**Addendum No. 2
COUNTY OF TULARE – Springville Library**

Springville Library
County of Tulare
569-0003

Subject: Addendum # 2

ADD 02- DRAWING 2.01
Added to Construction Documents via Addendum 02

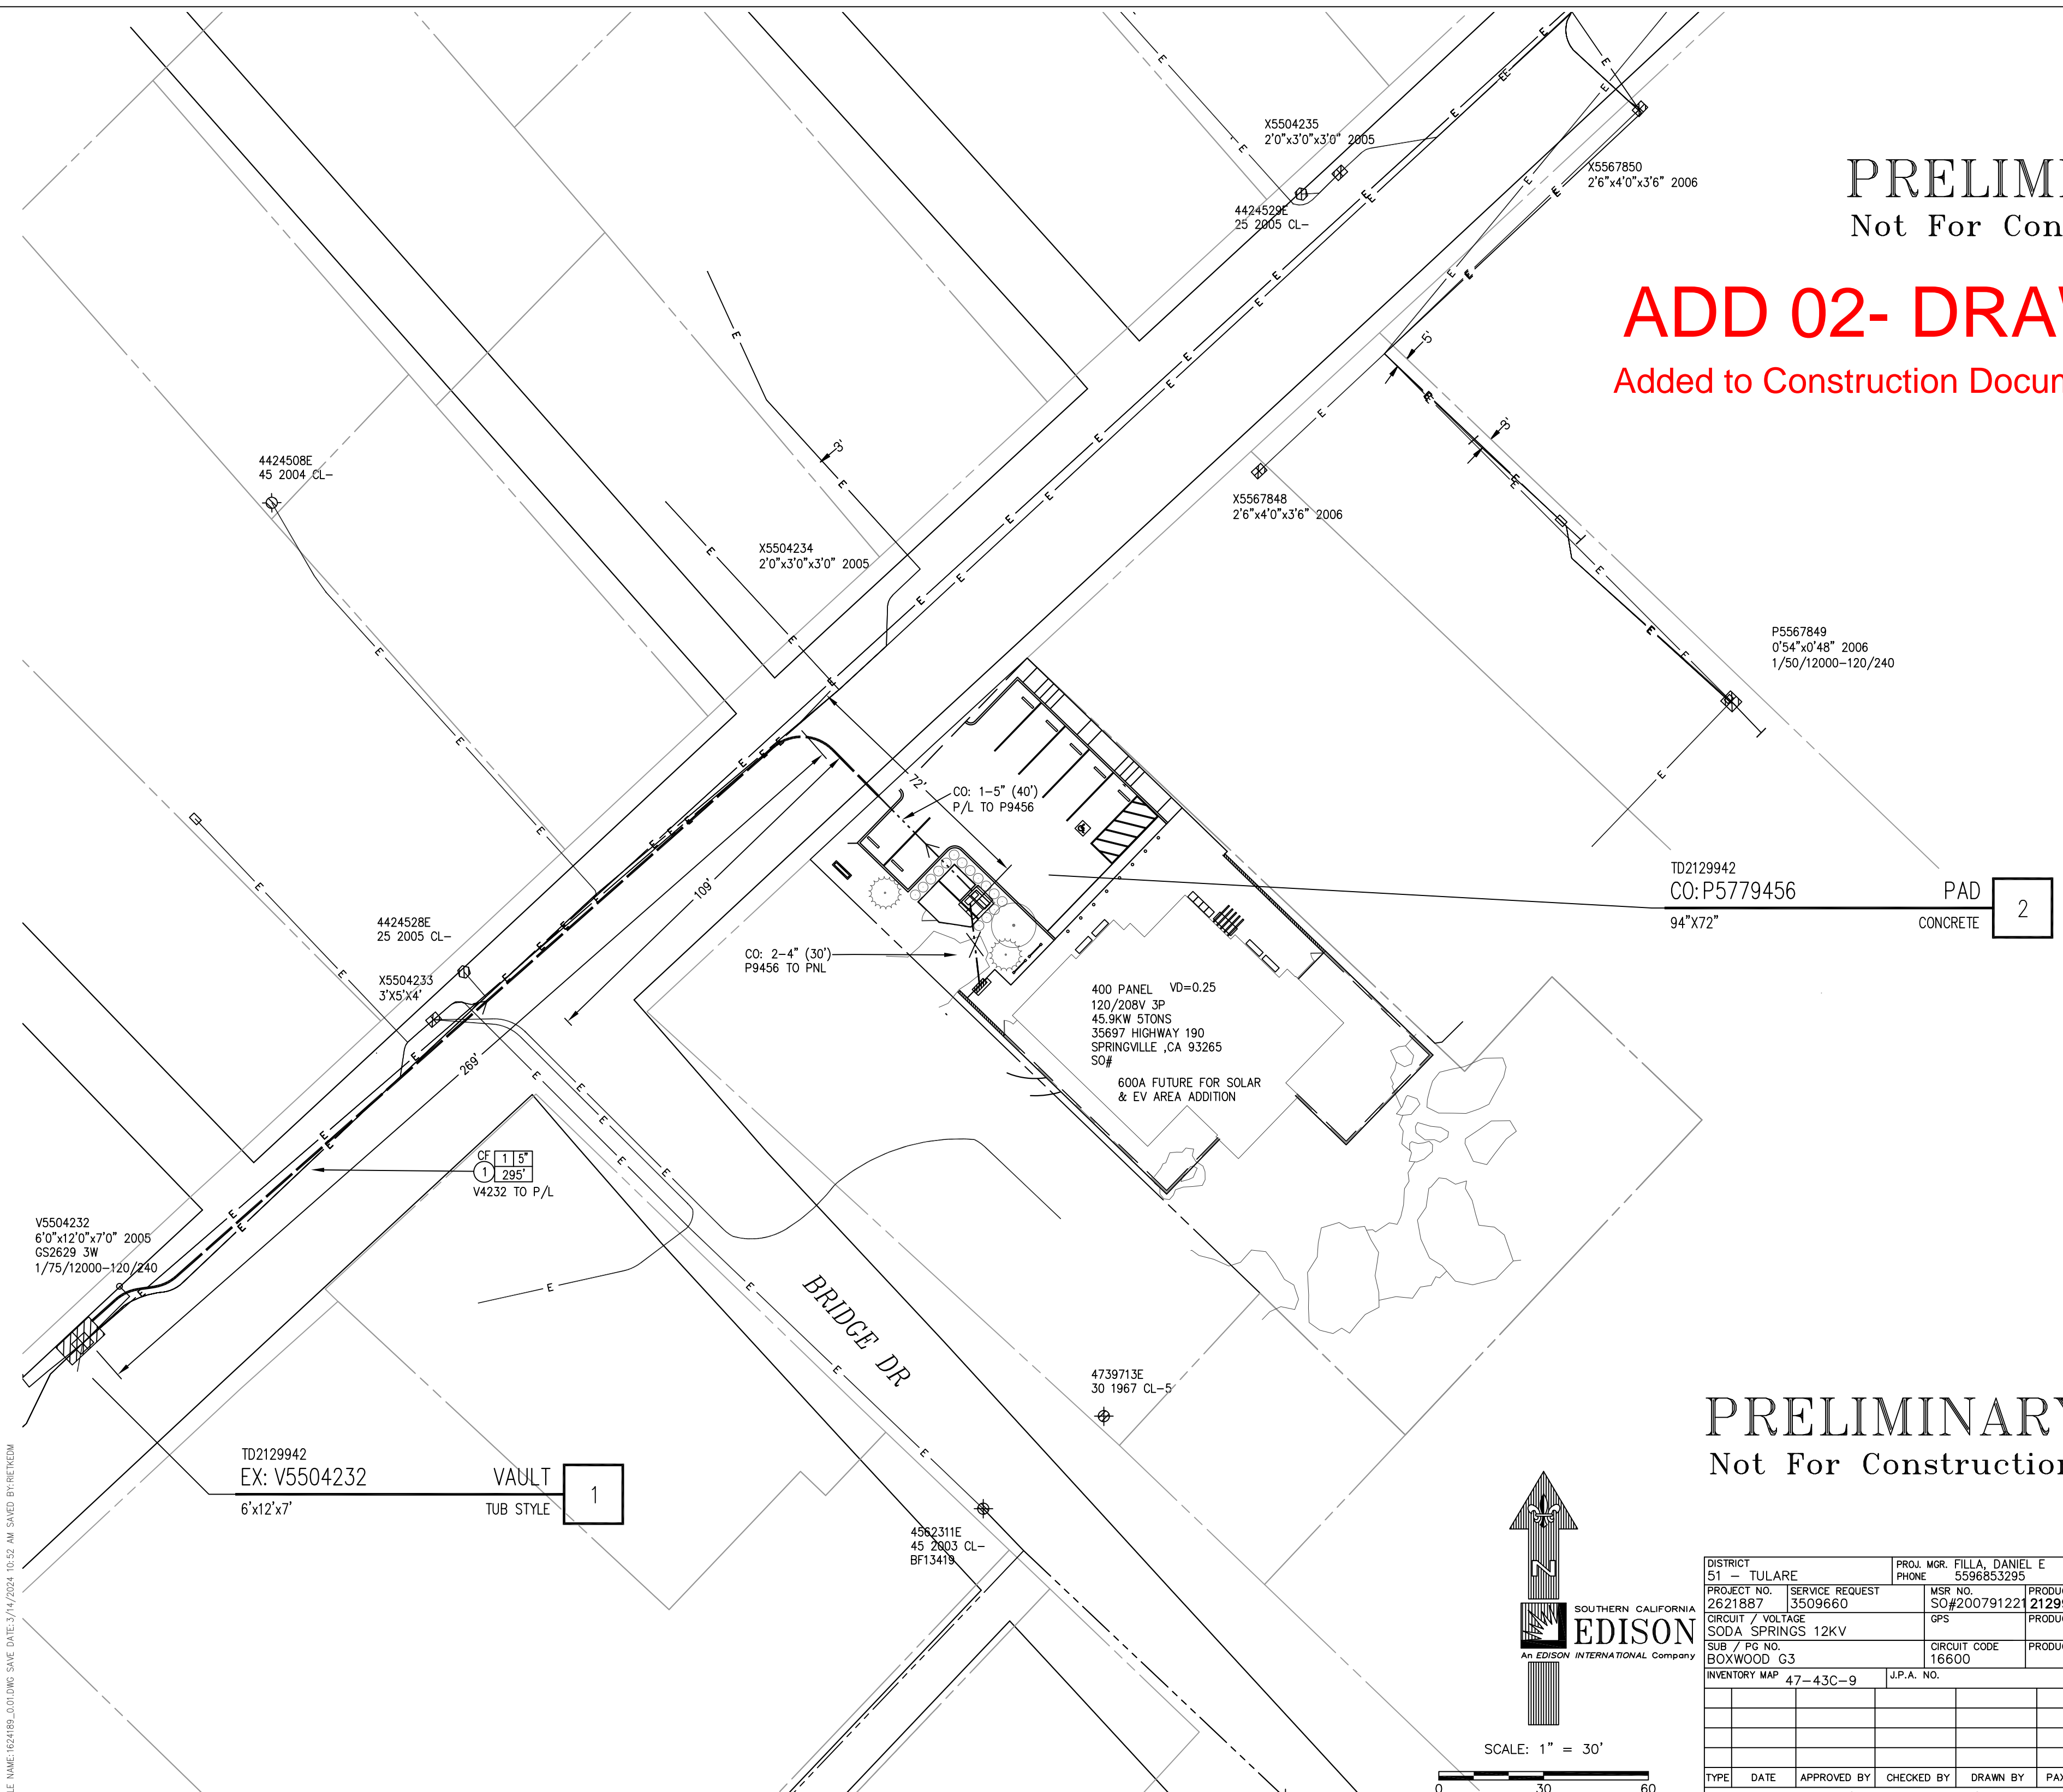
2.2.1 Add the attached, **AT&T SPECIFICATIONS.**
- 2.3 Refer to Electrical Sheets:**
2.3.1 Add the attached Addendum Drawing 2.01- PRELIMINARY EDISON DRAWING No. 1624189_0.01 for reference.
